DATE: 09.26.2018
TO: ProTrak
FROM: Mitesh Baxi
Traffic Engineering

■ **HOME 2 SUITES BY HILTON [TRC Plan Review]**

↻ Initial Review Note ↻

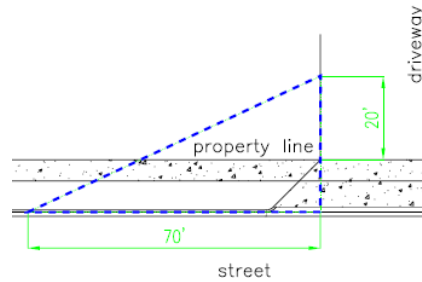
- The site is within 500’ of a signalized intersection. Revise all sheets to accurately illustrate the existing conditions on and surrounding this parcel. Show all adjacent traffic signs, lane configurations, traffic control devices, pavement markings and ramps for the intersection Market St and Eastwood Rd on the site plan. Please refer to the Technical Standards and Specifications Manual (link is below) Ch. VII C.1.a.2.for specific information and distance requirements. Contact Traffic Engineering at 341-7888 if you need assistance locating these elements.
